Sent: 7/05/2020 12:21:21 PM
Subject: Objection to DA 319/2020 (44 Bower Street Manly)
Attachments: 44COM3.pdf;

Re: Redevelopment of 44 Bower Street Manly (DA 319/2020)

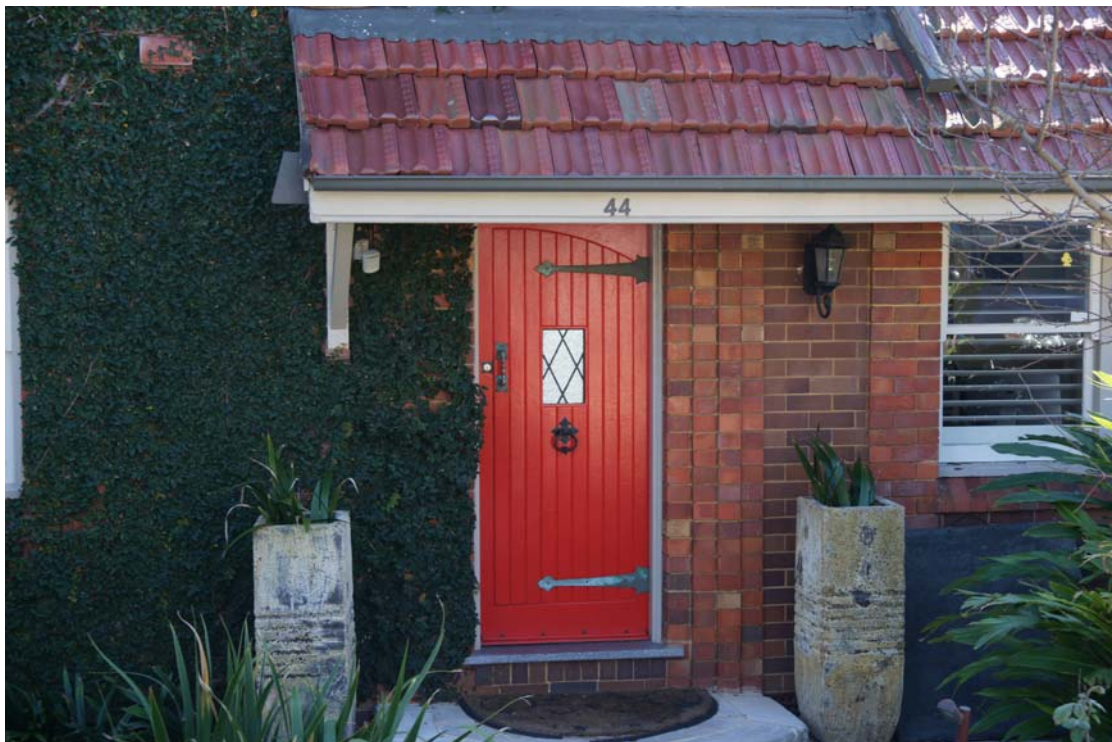
The author's description of the facade brickwork is misleading, he says "it is hard to see any ornamentation" in fact, as illustrated below, the building (under the 'Ficus' vine currently covering it) has significant decorative brickwork features on the facade. For example there are prominent constructions around the four smaller upper windows. A determined close inspection would have easily revealed this. Given it is the street facade and the period of its construction, such detail would also be expected.

Number 44 Bower Street on 18/08/2016. There is 'Ficus' vine hidden decorative brickwork around the 4 windows at the top of the facade. Note the view corridor between 44 and 42 Bower Street which will be blocked by a proposed garage to be built on the present vehicle hard stand. The façade faces south.
